**DOCUMENT 00 90 00
ADDENDUM**

ADDENDUM NO. [1] Date: March 30, 2021

**RE: SCHOOL DISTRICT OF HOLMEN
EMPIRE STADIUM COLONNADE REPLACEMENT
1001 McHUGH RD
HOLMEN, WISCONSIN 54636
HSR PROJECT NO. 21003**

FIRST FLOOR AND SOFFIT PLAN

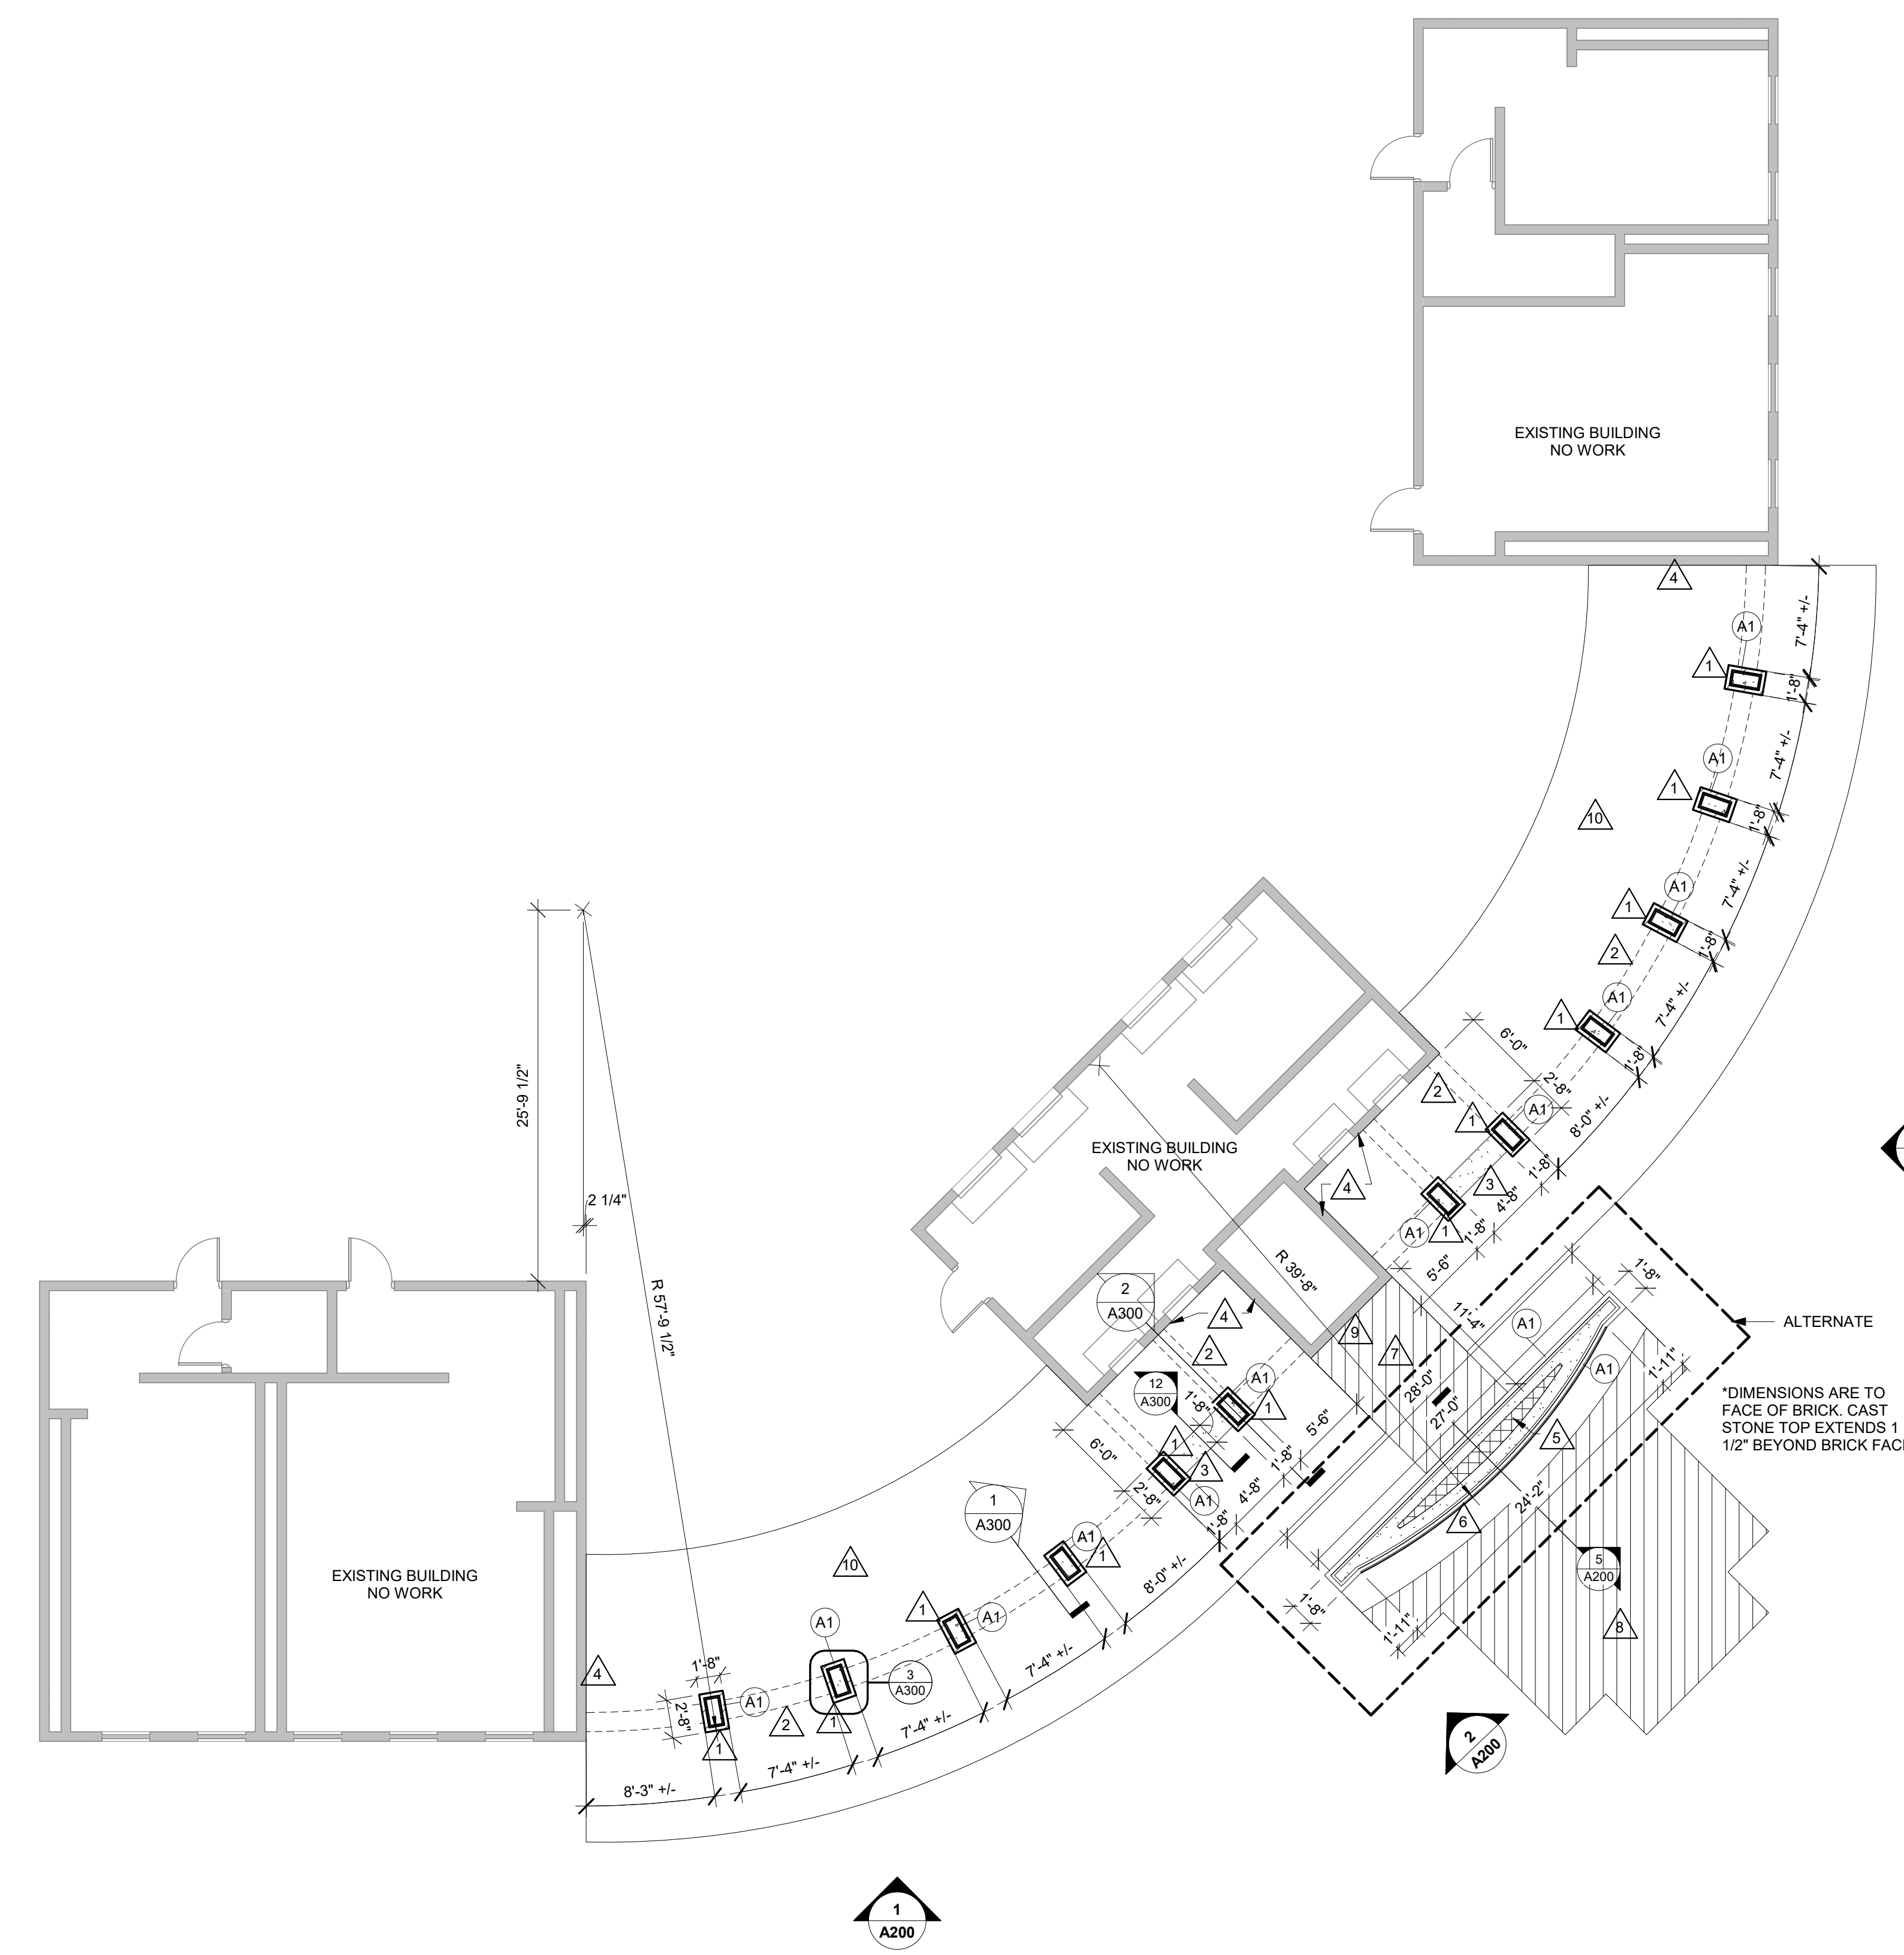
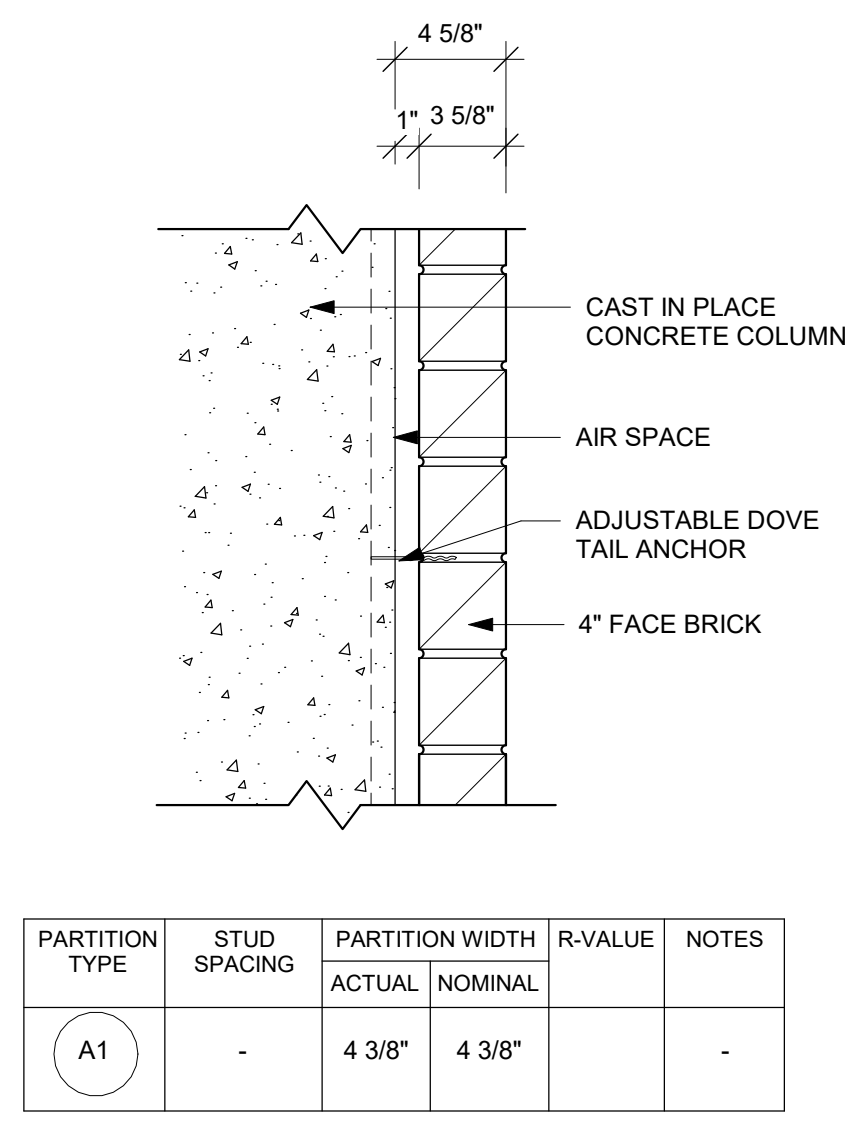
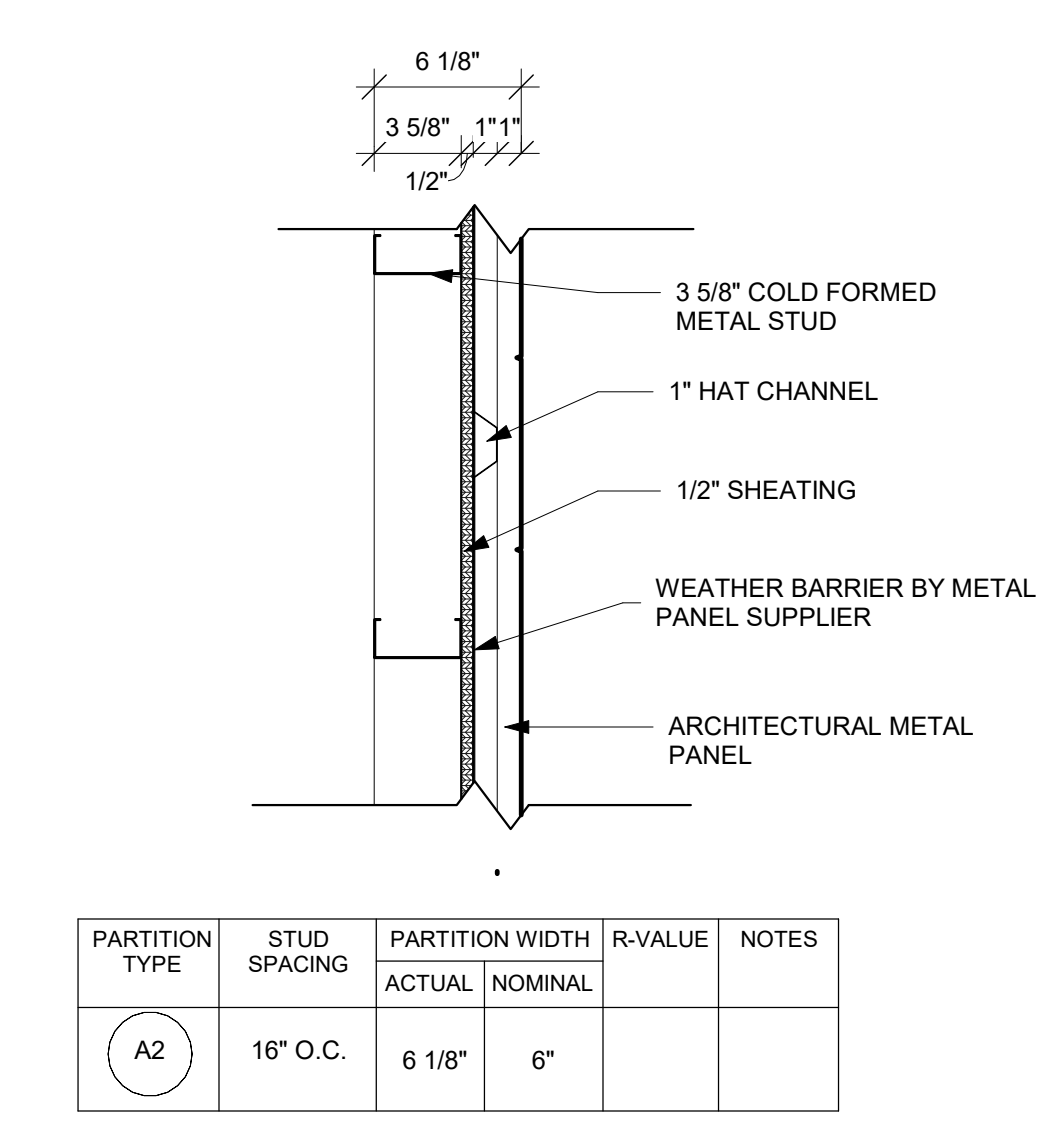
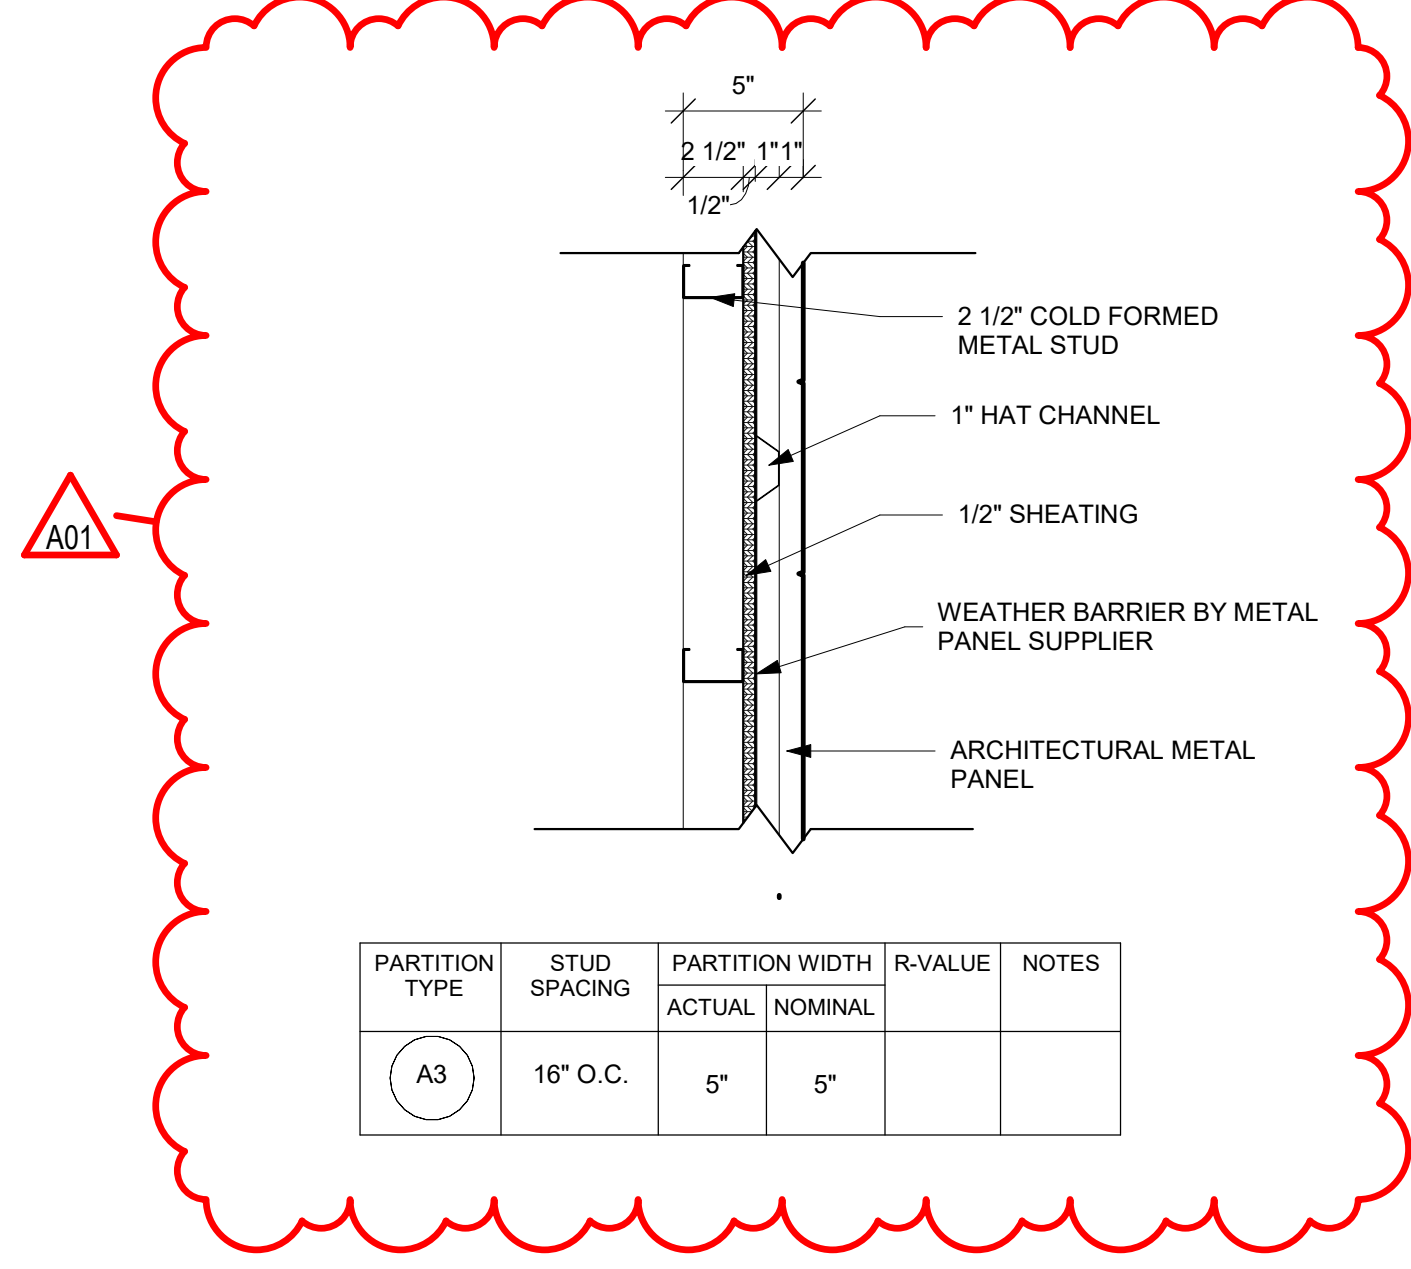
2. Sheet A100 FIRST FLOOR AND SOFFIT PLAN 30 x 42 attached hereto
 - a. Revisions clouded on Drawing.
 - b. Wall type A3 added for soffit construction.
 - c. Clarification of base bid and alternate scope for paving in Key Notes.
3. Sheet E100 – ELECTRICAL LIGHTING PLAN: No Drawing reissued.
 - a. Light Fixture Schedule: Owner to purchase and furnish type "OA" light fixtures to the electrical contractor for installation.
Contractor to provide all dimming controls as indicated in the light fixture schedule remarks.

PARTITION TYPE	STUD SPACING	PARTITION WIDTH		R-VALUE	NOTES
		ACTUAL	NOMINAL		
A3	16" O.C.	5"	5"	-	-

- CENTER OF NEW STEEL TUBE FRAMING
- FOR SOFFITS PERPENDICULAR TO COLUMNS USE WALL TYPE A3 AND THE OVERALL WIDTH IS 1'-3"
